PECOS DISTRICT CONDITIONS OF APPROVAL

OPERATOR'S NAME:	Devon Energy Production Company, L.P.
LEASE NO.:	NM-0405444A
WELL NAME & NO.:	Aldabra 27 Fed. Com. #5H
SURFACE HOLE FOOTAGE:	0065' FSL & 1430' FEL
BOTTOM HOLE FOOTAGE:	2600' FSL & 2310' FEL Sec. 22
LOCATION:	Section 27, T. 23 S., R. 31 E., NMPM
COUNTY:	Eddy County, New Mexico

Cross Section of a Typical Lead-off Ditch

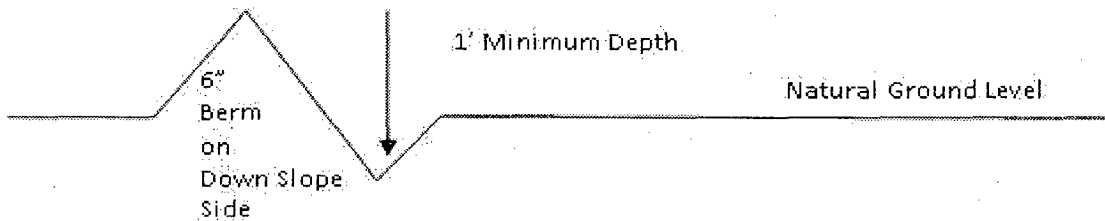
A typical lead-off ditch has a minimum depth of 1 foot below and a berm of 6 inches above natural ground level. The berm shall be on the down-slope side of the lead-off ditch.

All lead-off ditches shall be graded to drain water with a 1 percent minimum to 3 percent maximum ditch slope. The spacing interval are variable for lead-off ditches and shall be determined according to the formula for spacing intervals of lead-off ditches, but may be amended depending upon existing soil types and centerline road slope (in %);

Figure 1 – Cross Sections and Plans For Typical Road Sections

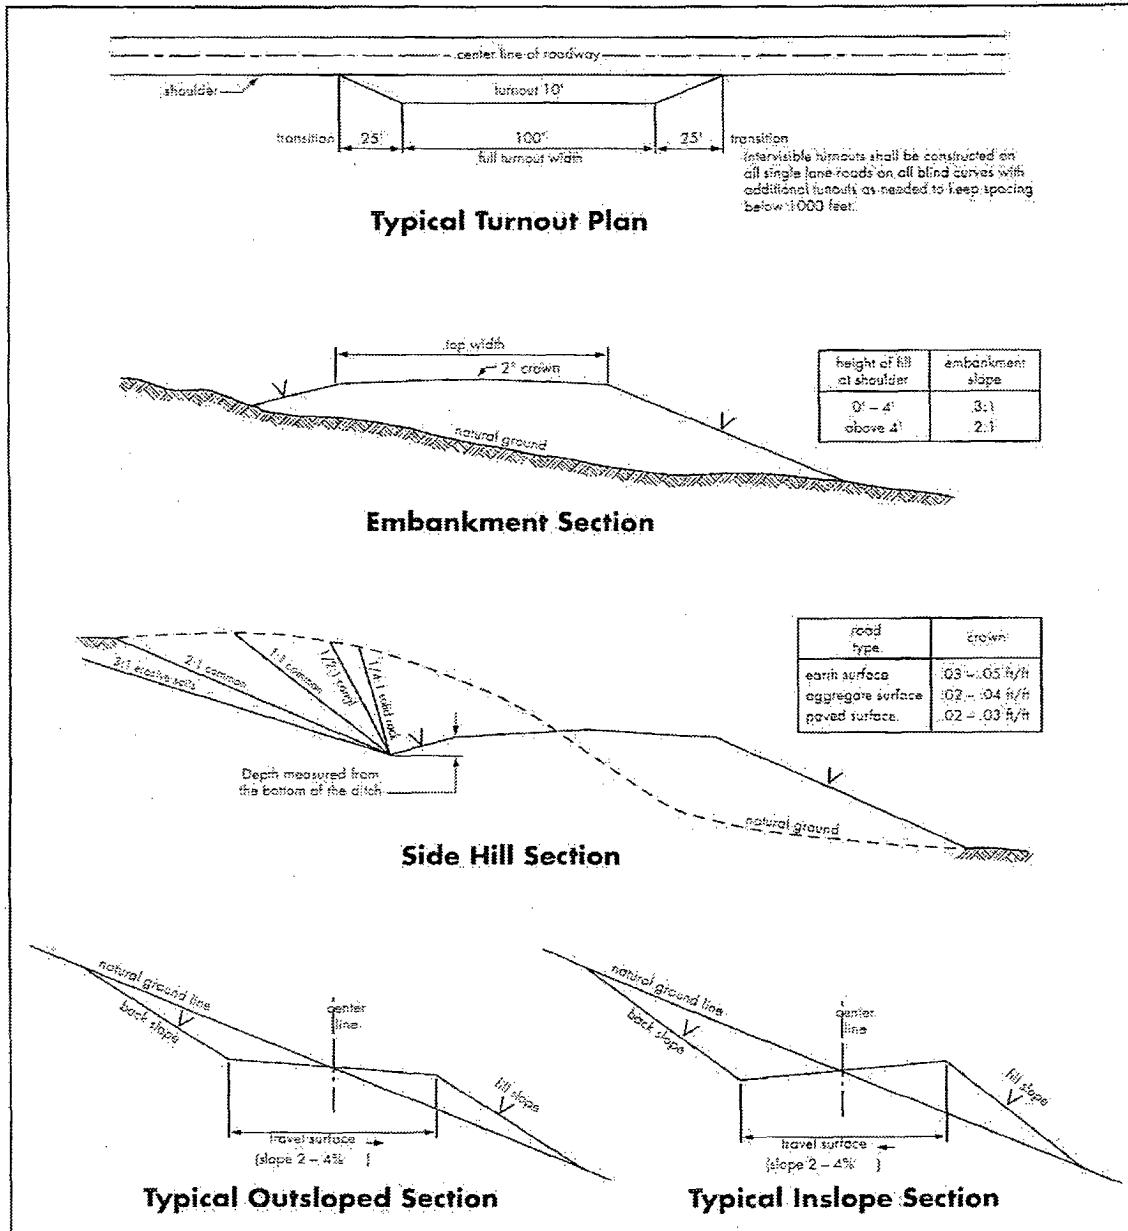
Crowning shall be done on the access road driving surface. The road crown shall have a grade of approximately 2% (i.e., a 1" crown on a 14' wide road). The road shall conform to Figure 1; cross section and plans for typical road construction.
